ADDENDUM, CHANGE ORDER, DRAWING,
DEFERRED APPROVAL WORKSHEET
and TRANSMITTAL MEMO

Roosevelt School

JOB NO. : 88107 (BFGC NO. 88-142)
NAME : ROOSEVELT SCHOOL MODERNIZATION
ADDRESS : BAKERSFIELD, CA.

BUDG 100 MECHANICAL PLATFORM
 ROOSEVELT ELEM. MODERNIZATION
 BAKERSFIELD CITY SCHOOL DISTRICT
 OSA FILE NO. 15-6 OSA AFFILIATION NO. A-51474

ROOF UNIT & STAFF DINING "MODIFIED"

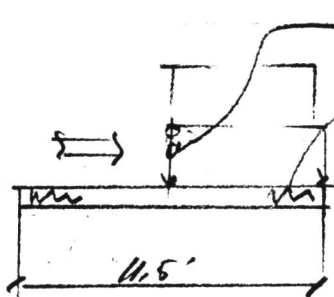
BY PASS (E) DOUBLE ROOF
FRAMING BY HAVING THE
NEW PLATFORM SPAN 11'-6"
BTWN THE (E) STEEL BEAM
& THE (E) BRICK WALL.

USE 2-4x8 12L.
2x8 @ 24" TYP.
SPANNING 11'-6"
FOR PLATFORM FRAMING
TO SUPPORT NEW
EQUIP.

SK
 10

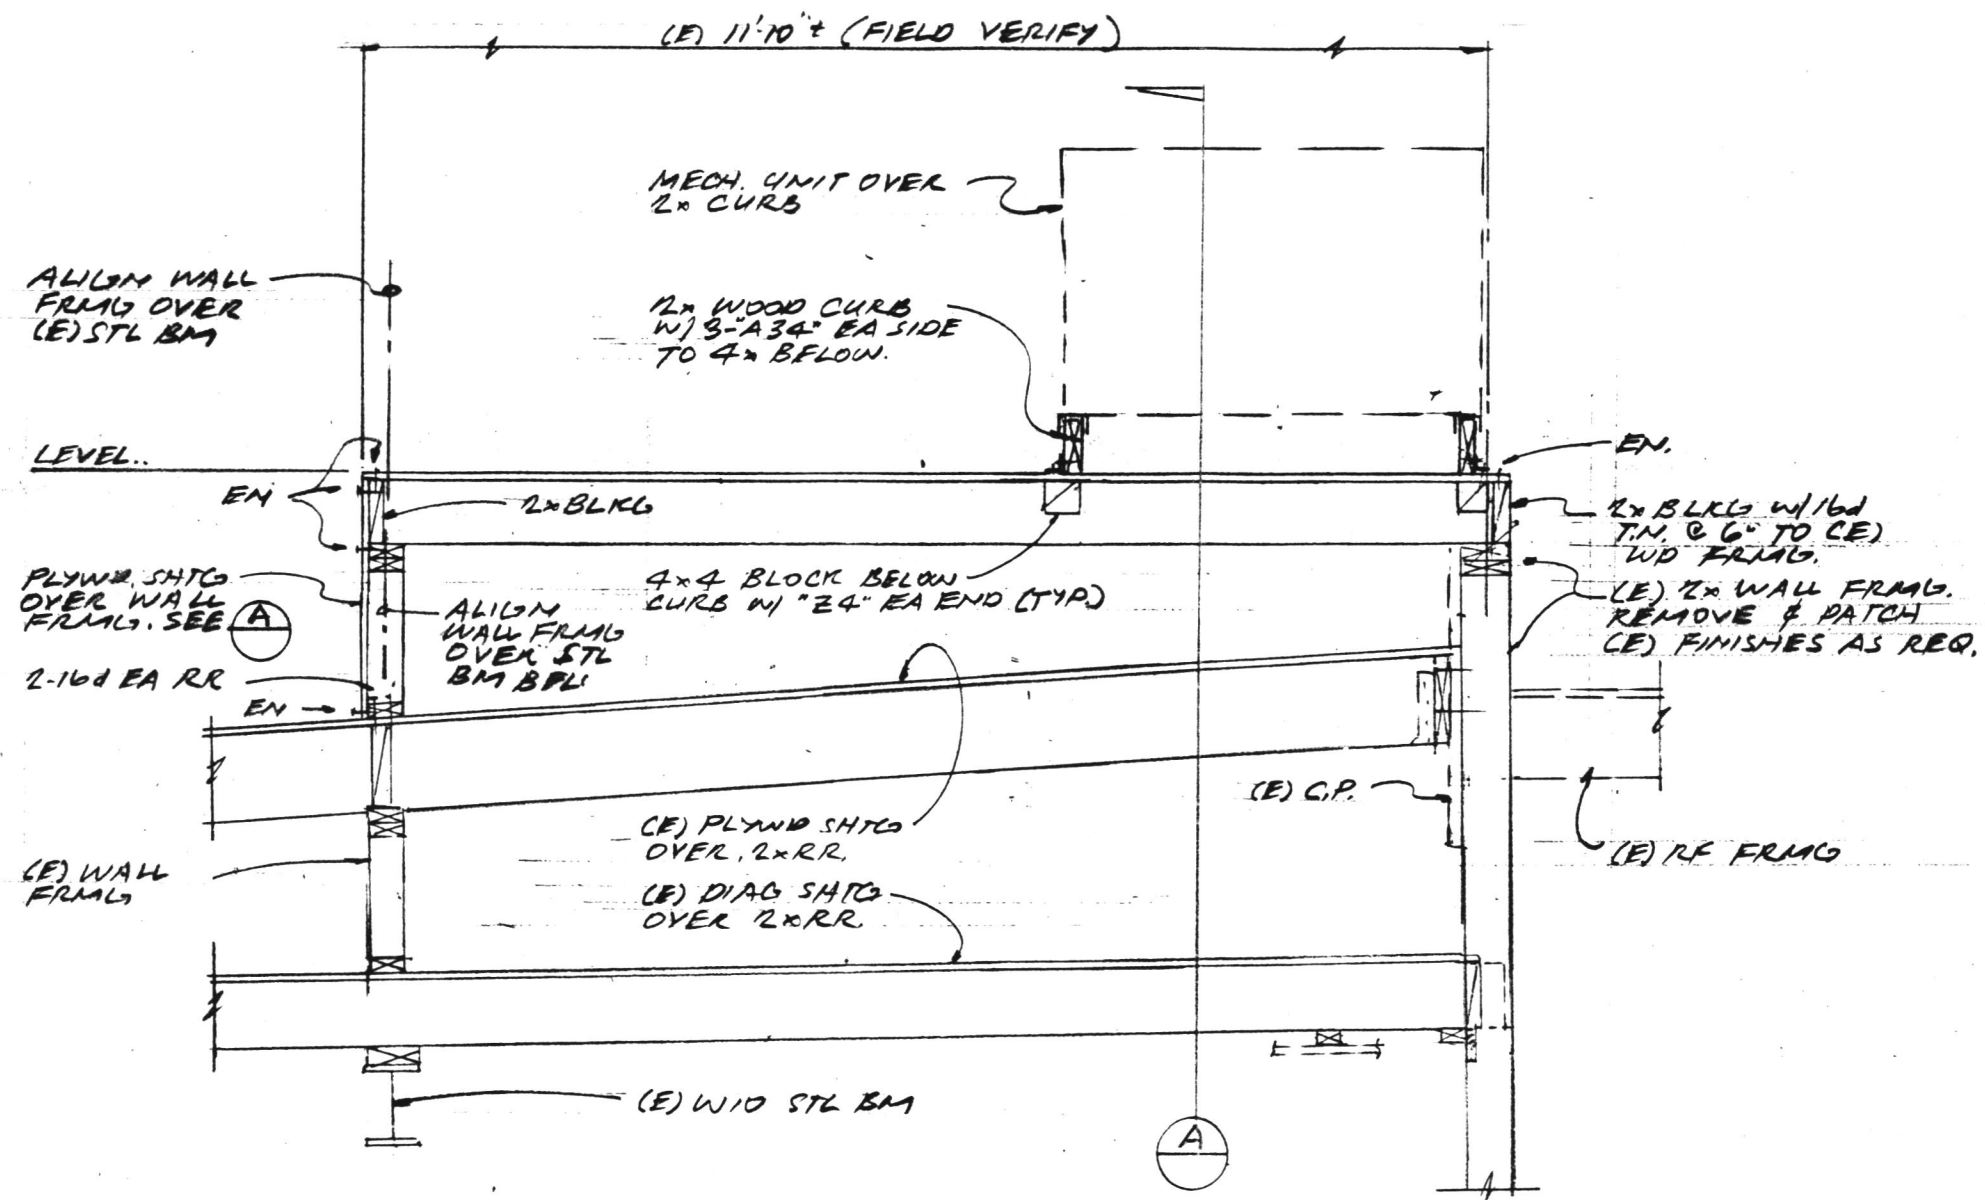
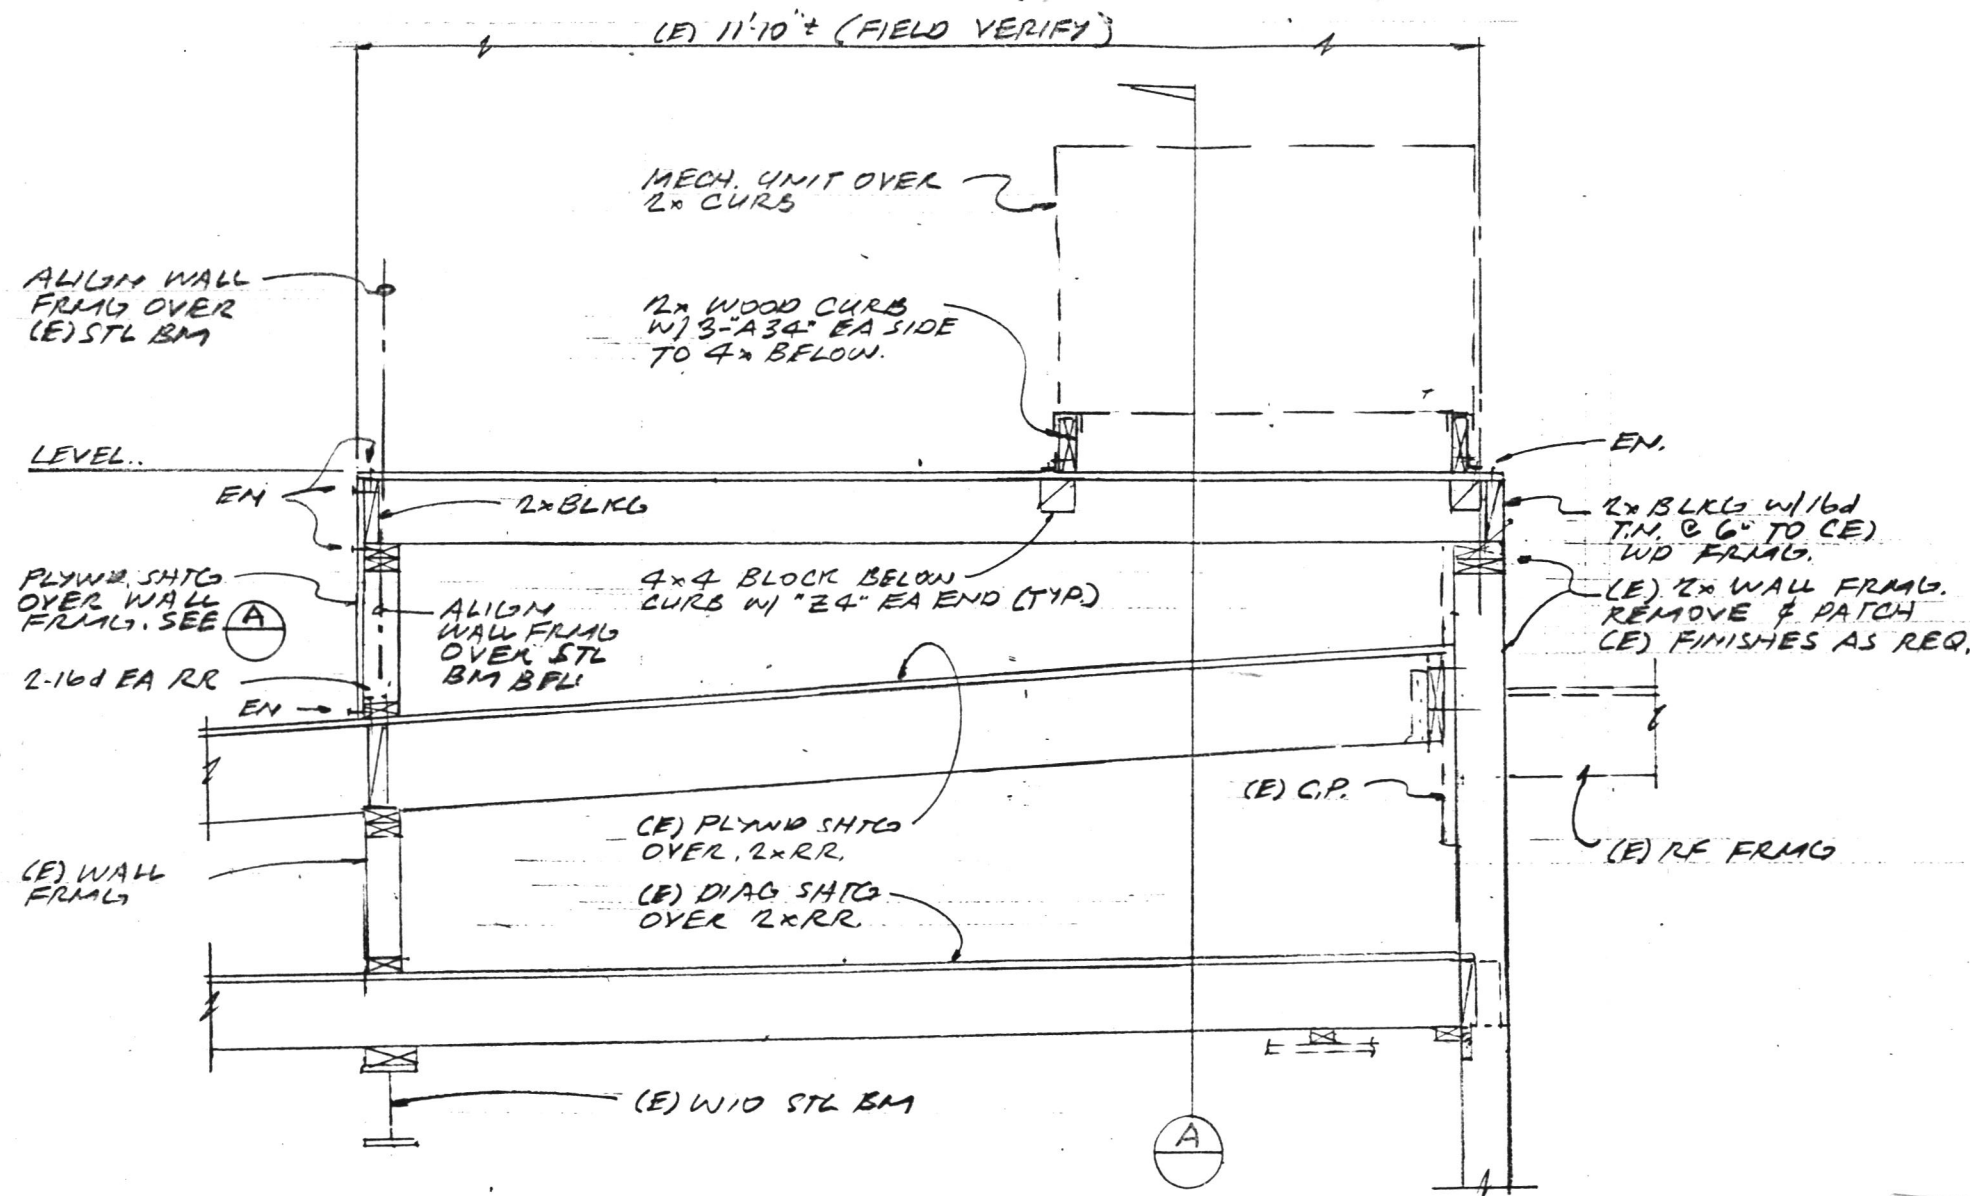
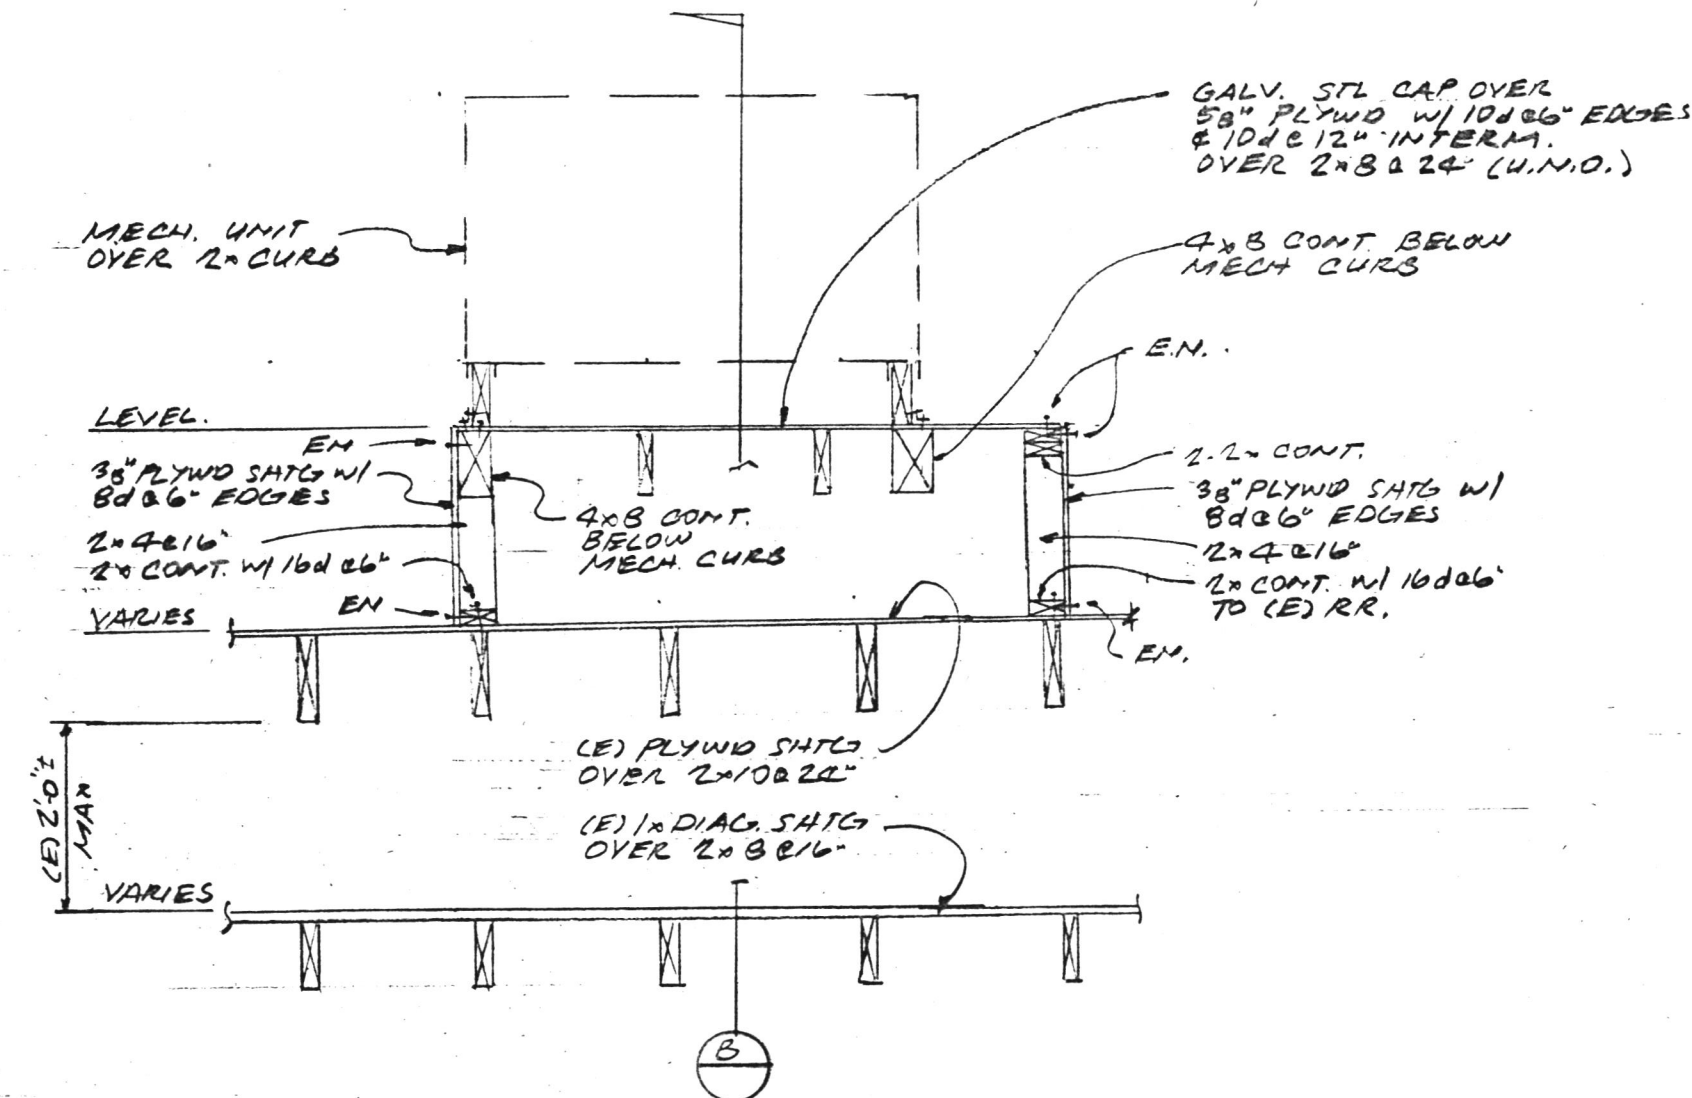
B "6/S2.00 MODIFIED" 1/2"=1'-0"
 NOTES 1. SEE **A** FOR NOTES.

A "GA/S2.00 MODIFIED" 1/2"=1'0"

PRELIMINARY APPROVAL ONLY
 A Change Order is Required
 By V&V Date 9-21-91

SK
7

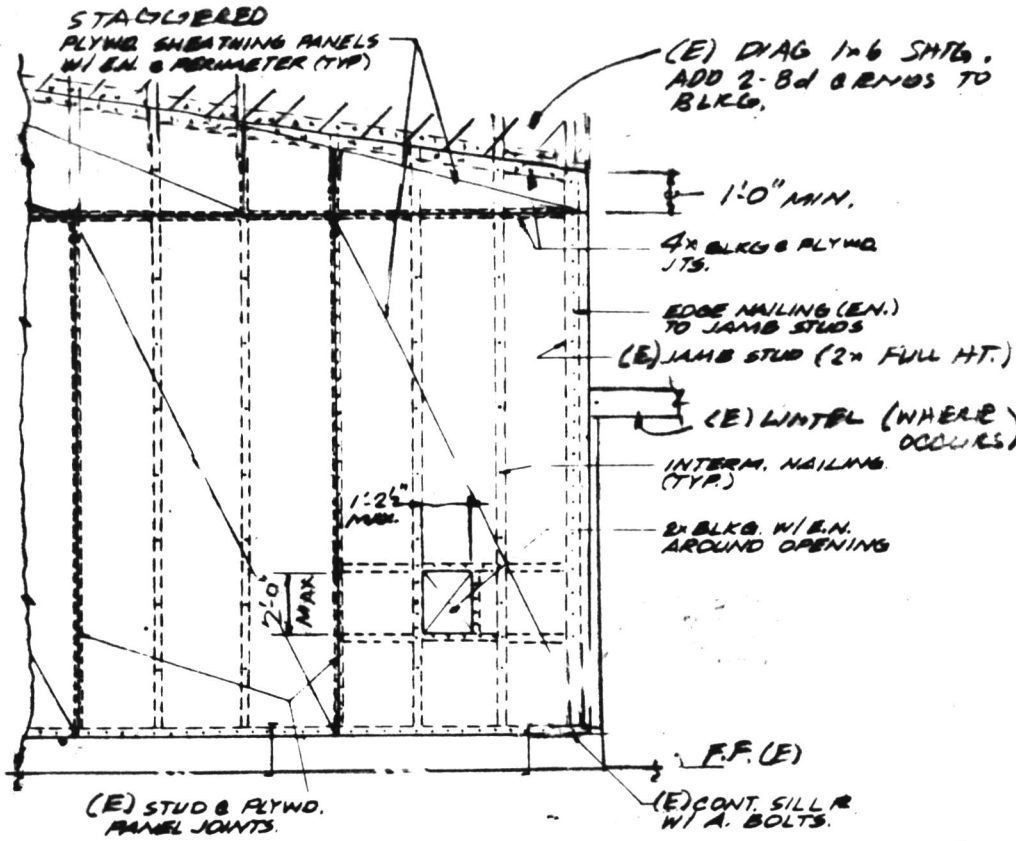
RM. 401, 402, 501 & 502 SHTG. CLARIFICATION

1. CE) EXPOSING SHELF IN ROOMS 401, 402, 501 & 502 HAS BEEN REMOVED TO EXPOSE CE) STUDS. (SEE KEY NOTE 701 ON SHEET A7.00.) THE CE) SHEAR CAPACITY OF THE WALL NEEDS TO BE PUT BACK. ~~SEE SHEET 701~~ ~~TO~~ PLEASE REVIEW, APPROVE & FORWARD THE ATTACHED "SHEAR PANEL DETAIL" TO OSA FOR PERM. APPROVAL.

1. PLYWG SHTG SHALL BE 3/4" THICK, APA RATED SHTG, 40/20, EXPOSURE I, W/ 10d @ 6" O.C. EDGES & BOUND. & 12" O.C. IN FIELD. 10d NAILS SHALL BE .148" Ø x 2 3/8" LONG MIN.
2. PLYWG SHTG (AS SHOWN ABOVE) SHALL BE INSTALLED IN ROOMS 401, 402, 501 & 502 WHERE 1x DIAG. SHTG HAS BEEN REMOVED.
3. WHERE DRIVING NAILS CAUSES SPLITTING, LEAD HOLES WITH A DIAMETER OF 60 TO 70 PERCENT OF THE NAIL DIAMETER SHALL BE PROVIDED.

SK 12

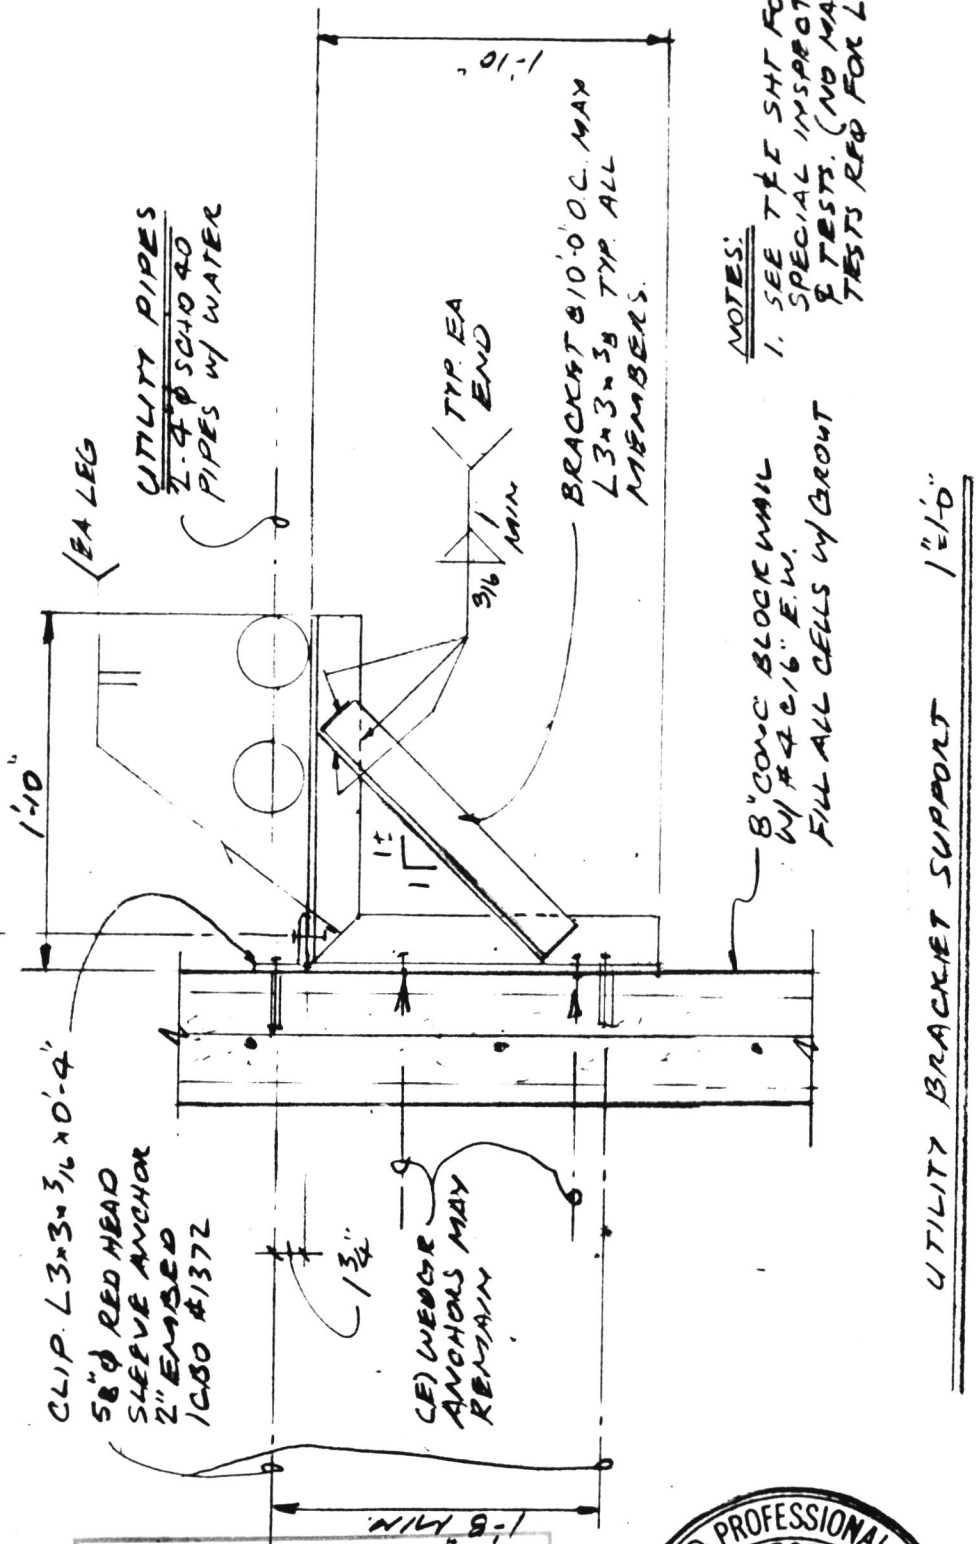
PIPING SUPPORT BRACKET

1/2" ϕ BOLT (DRILL BOLT HOLE - DO NOT BURN.)

CLIP L3x3x3/16 x 0'-4"
5/8" ϕ RED HEAD SLEEVE ANCHOR 2" EMBEDDED 1050 #1372

BRACKET 8' 0" O.C. MAX L3x3x3/16 TYP ALL MEMBERS.

ROOSEVELT
BRACKET
STRENGTHENING

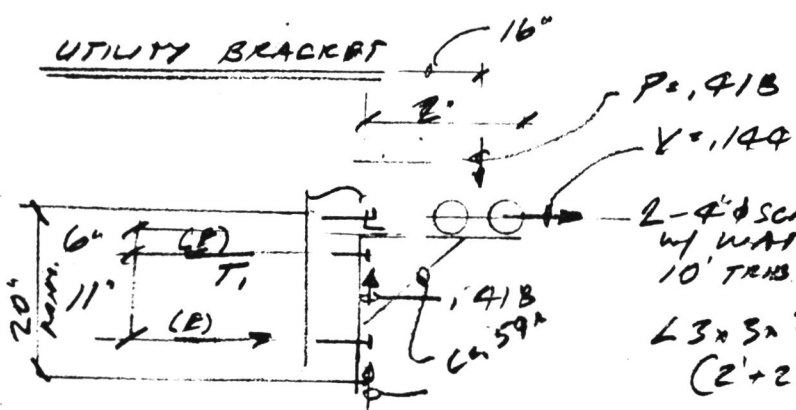
USE (2) L3x3x3/8 BRACKET
ADD L3x3x3/8 CLIP @
TOP W/ 1/2" BOLT &
5/8" SLEEVE ANCHOR
& CLIP & BOLT
20" APART MIN.

ADD CLIP @ T & NEW ANCHOR @ BOTT

SK
8

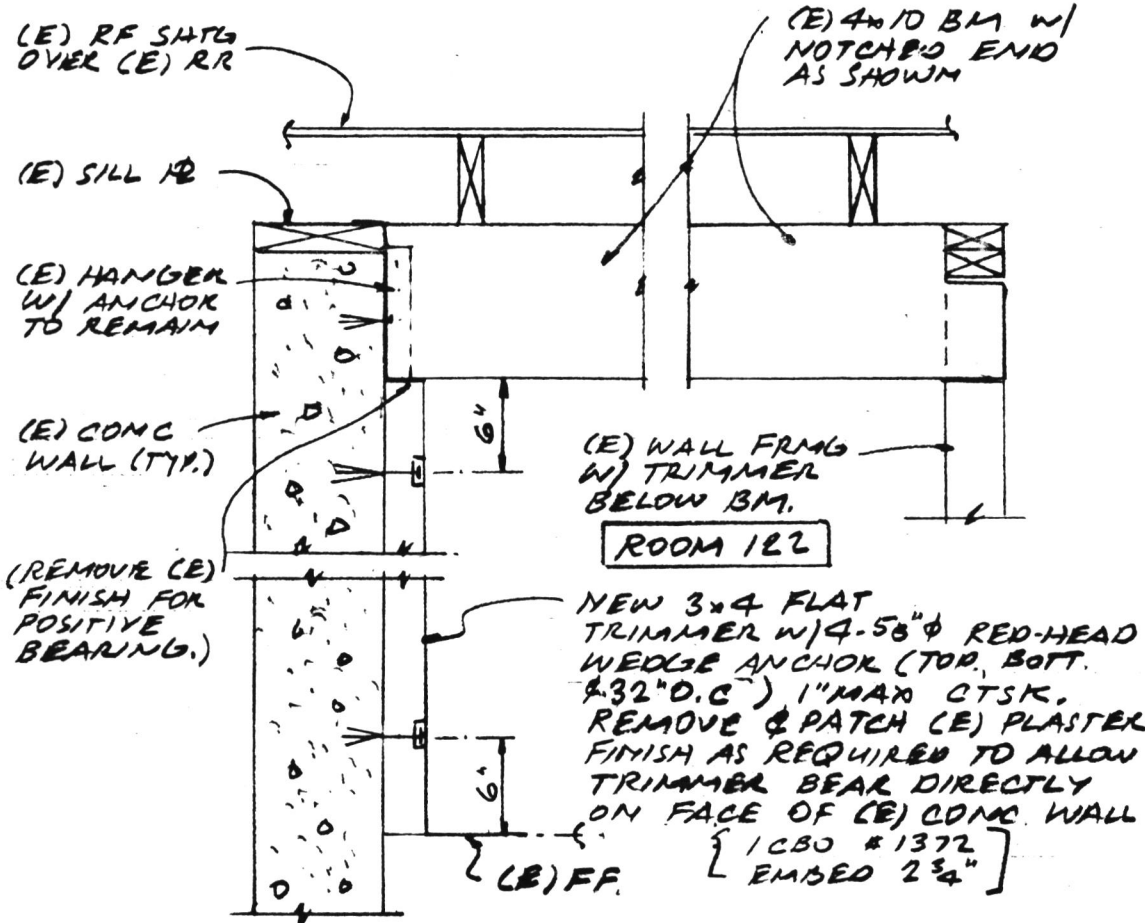
(E) BEAM ELEVATION STRENGTHENING 12/1-0'

NEW RR UNIT C CONF ROOM

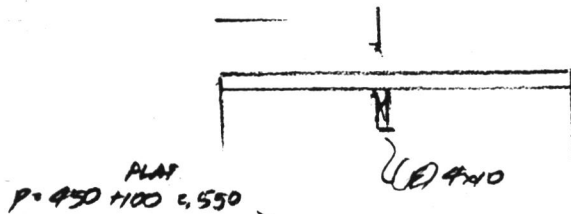
USE (E) 4x10 BM
CHECK END COND.
IN FIELD FOR
ADJOUACY.
